SERVICE BULLETIN

M-1180

Safety Recall Code 0122

SAFETY RECALL-2004 DYNA MODELS THROTTLE CABLE ROUTING

Figure 3. Fuel Tank Inspection Area

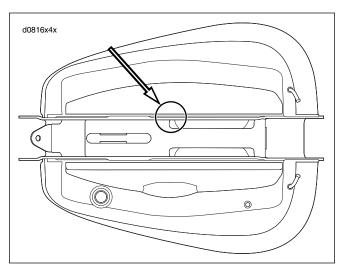
- 1. See Figure 3. Determine extent of wear on fuel tank:
 - a. If throttle cables have worn or removed paint but have not damaged the metal structure of fuel tank, repair wear using Harley-Davidson Touch-up paint of the correct color.
 - If wear has damaged the metal structure of fuel tank, order a new fuel tank according to instructions specified under Credit Procedure.
- Replace cables according to instructions in the 2004 Dyna Models Service Manual.
- 3. See Figure 2. Install **new** cable straps (1) so after installation, ends of cable straps are facing top of vehicle.
- Install fuel tank according to instructions in the 2004 Dyna Models Service Manual.
